Coordination transmittal and sheet index

Orion Biologics | Suite 214 laboratory renovation | record package

REVISION C

RFI-214-17 - Lab B corridor opening

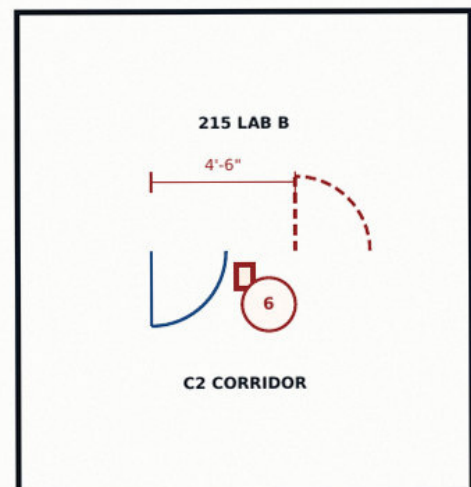
Revision B opening conflicts with the installed security rough-in. Confirm governing opening, swing, reader jamb, controller branch, and whether the old field background may be used for set-out.

VOID D-214A SET-OUT.

Shift opening 4'-6" west.

Use D-214B; swing south into C2.

Set CR-6 on corridor-side east jamb.

DC-6 branch is LP-2 / L2-15.

Revision C governs construction.
